EAST LINDSEY LOCAL PLAN CORE STRATEGY EXAMINATION
MATTER 8 – HOUSING SUPPLY INCLUDING 5 YEAR SUPPLY OF
DELIVERABLE SITES

This Hearing Statement is made for and on behalf of the HBF which should be read in conjunction with our representations to the draft and pre submission Local Plan Core Strategy consultations dated 8th August 2016 and 25th January 2017 respectively. This representation answers specific questions as set out in the Inspector's Matters, Issues & Questions document published on 26th May 2017.

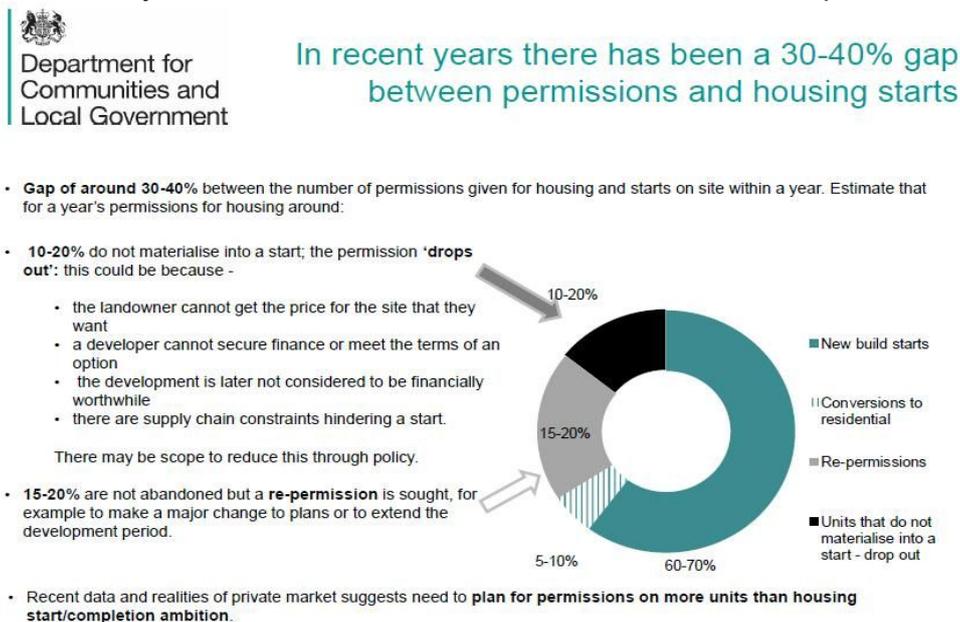
4. Is the supply from windfalls in CS Table A (as set out below) justified and where is this justification set out? How do these forecasts compare with past performance? Is past performance a reasonable forecast of what will happen (given the current Local Plan dates back to 1995/1999 -

see para 30, page 28 of the CS which sees the number of windfalls reducing)?

It is reasonable to expect the number of windfalls sites to reduce in the future as such sites are a finite resource. In a plan-led system most sites will have been identified and allocated therefore to avoid any double counting windfall site allowances should be excluded from HLS in the earlier years.
